**CITY OF FRANKLIN
SPECIAL COMMON COUNCIL MEETING*
FRANKLIN CITY HALL – COUNCIL CHAMBERS
9229 WEST LOOMIS ROAD, FRANKLIN, WISCONSIN**

APPROVAL <i>Slw</i>	REQUEST FOR COUNCIL ACTION	MEETING DATE May 14, 2015
REPORTS AND RECOMMENDATIONS	<p>Matt Talbot Recovery Services, Inc. 5 to 8 bedroom Community Based Residential Facility for the property located at 9132 South 92nd Street, Tax Key No. 886-9987-000; Letters and Petitions from Angeline Benning regarding Community Based Residential Facility at South 92nd Street and West St. Martins Road; Site Plan for a 5 To 8 Bedroom State Licensed Community Based Residential Facility Development (Matt Talbot Recovery Services, Inc., Applicant); Request from Matt Talbot Recovery Services, Inc. to extend water main along St. Martins Road, 90-degree bend to South 92nd Street, and past driveway to terminate water main at a possible future lot line. The Common Council may enter closed session pursuant to Wis. Stat. § 19.85(1)(g), to confer with legal counsel for the Common Council and City defense counsel who are rendering advice concerning strategy to be adopted by the body with respect to potential litigation with regard to the Matt Talbot Recovery

Exhibit PL-3

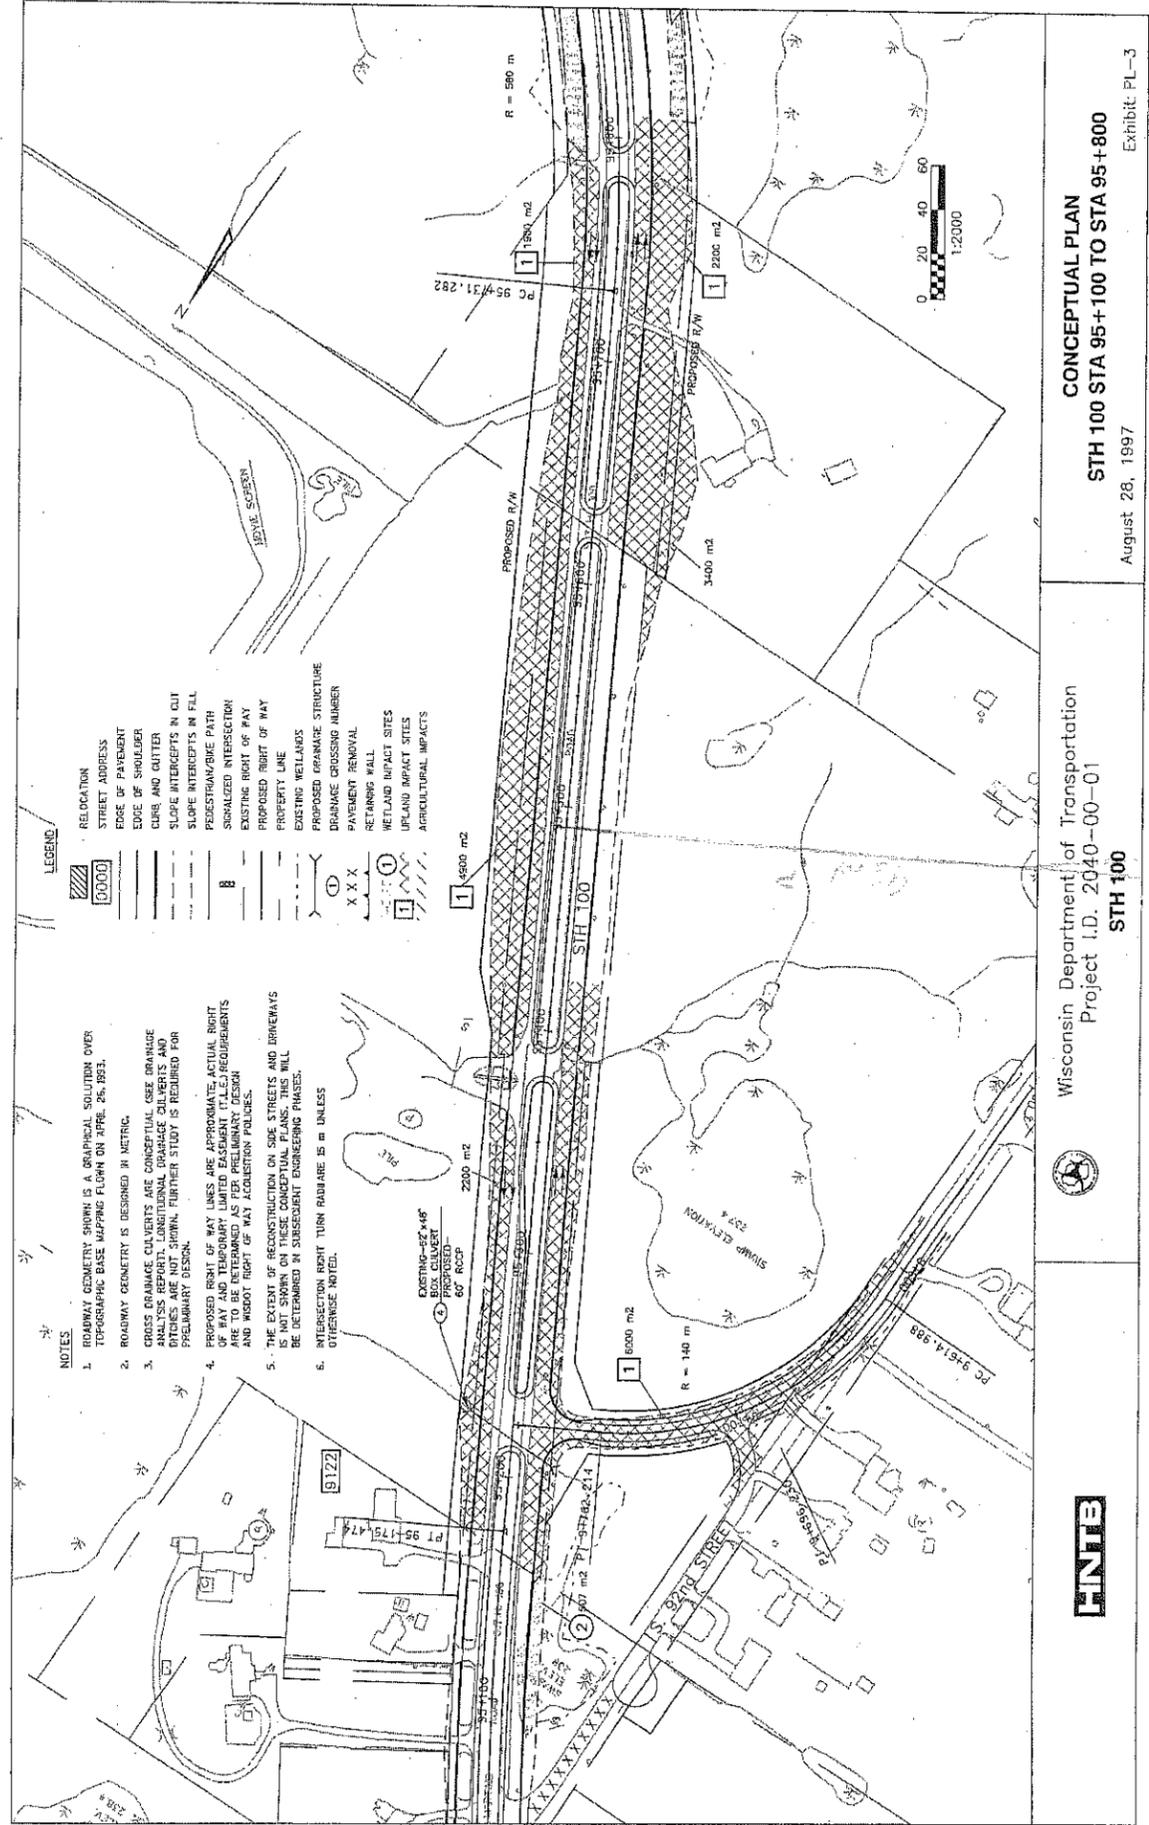
If this development were built, DOT would likely realign 92nd St. than relocate a new building/business since there is a fair amount of open space to look at this type of option and we feel this would be cheaper for us.
Just wanted to let you know, that in this specific circumstance, we feel there are options to moving 92nd St. (See attached)

I apologize for the delay in getting back to you since our phone call. I confirmed with Traci Gengler, our project manager assigned to the re-evaluation of Hwy 100 between 60th St. & Loomis Rd, that the attached drawing *is* DOT's latest plan for the area near 92nd & Hwy 100 .

If the City cannot set back any new development, we ask to be notified on what is expected to be built within the expanded highway footprint. If approval is obtained for an "early purchase" from our Madison Real Estate bureau, DOT would try to purchase the needed property from the owner, but the sale would need to be voluntary on the owners part, as DOT cannot use eminent domain prior to the envr doc being approved.

If our bureau does not give us the approval to proceed, then we would need to acquire the new building, provide relocation assistance to the owner, and demolish whatever new construction was built in the new highway footprint. As you can see, this is an added expense we would like to avoid.

Matt Talbot Recovery Services
Water Main Extension Option 1
Go to Ryan Road via St. Martins Road

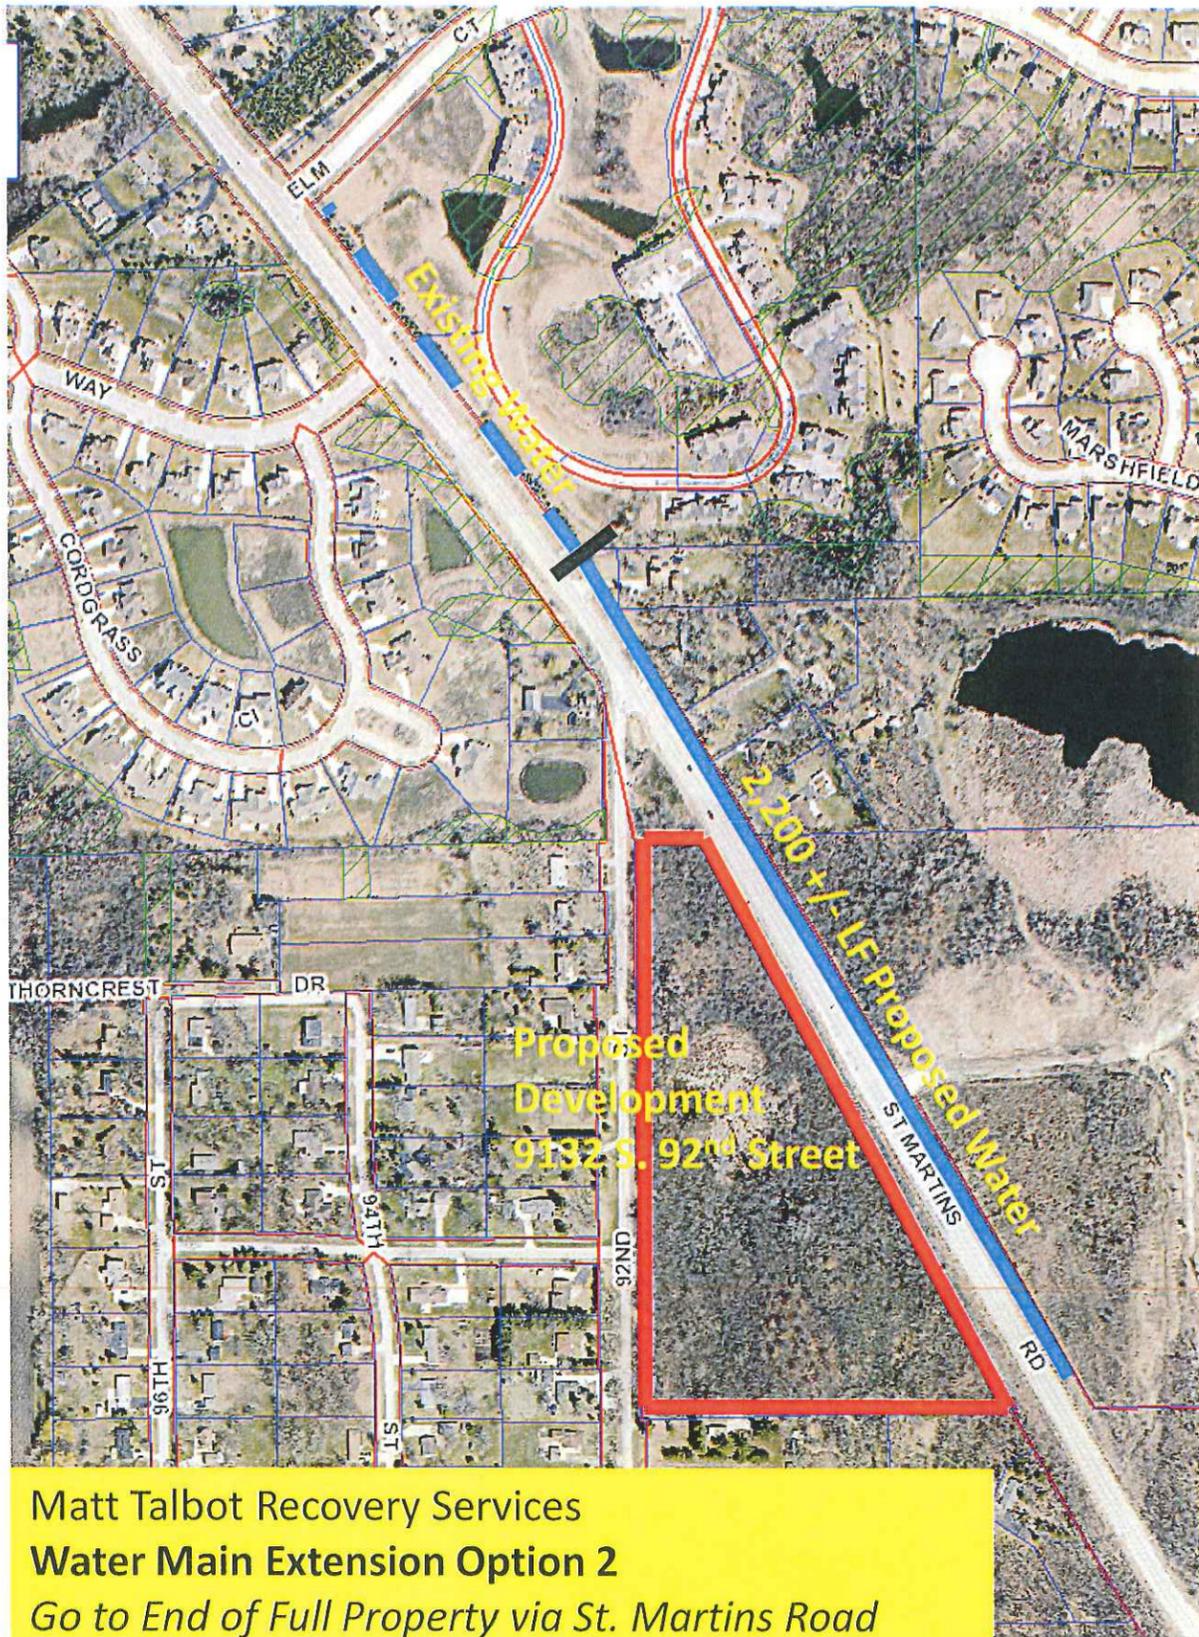
Option 1: Go to Ryan Road via St. Martins Road. This option consists of approximately 5,230 linear feet from the current terminus of the water system on the eastern side of St. Martins Road; extending it southward and eastward along St. Martin Road (Highway 100); crossing Ryan Road (CTH M); and connecting to a terminus of the existing water main on the south side of Ryan Road. A cost estimate of this option is approximately \$1,022,760. If the developer were involved, the City’s estimated cost is only \$406,440.
